BE-0002L-0110-EN

Technical Service Bulletin

Water leaking into cabin due to blocked air conditioning drain tube

IS220d, IS250, GS300, GS430, GS450h

• **For GS430 & GS450h**

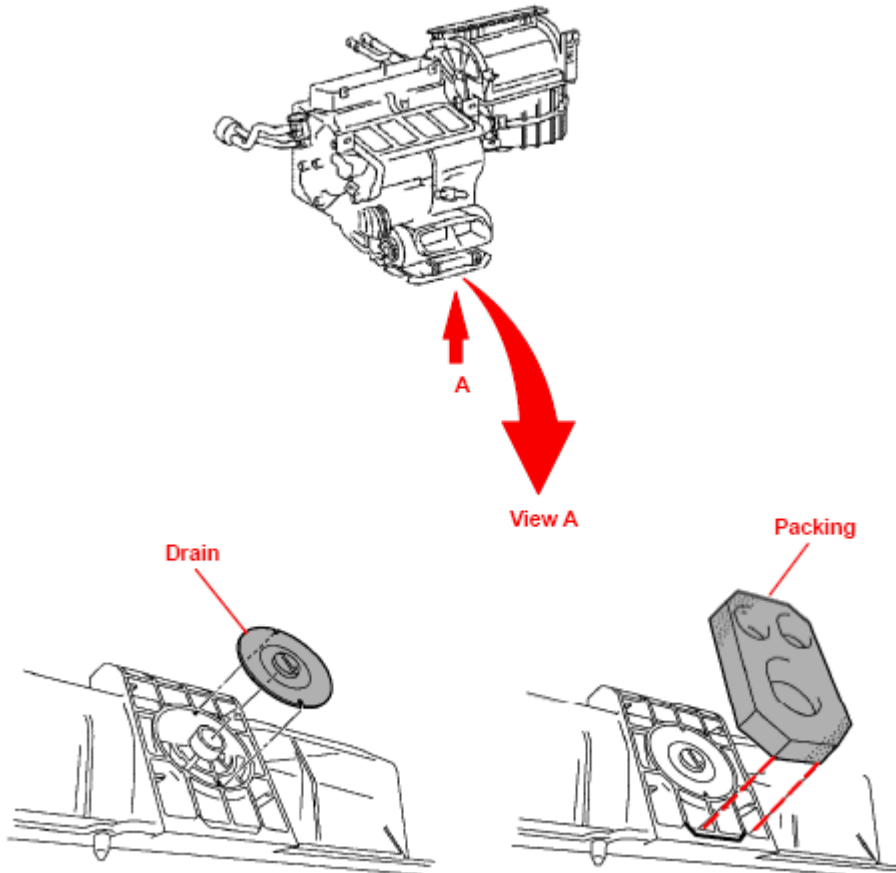
An improved HVAC evaporator drain and packing have been made available.

- 1. Remove the air conditioning unit.
Refer to TechDoc for R&R of air conditioning unit.
- 2. Remove the HVAC evaporator drain and packing.

- 3. Install the NEW HVAC evaporator drain and packing to the air conditioning unit.
- 4. Install the air conditioning unit.
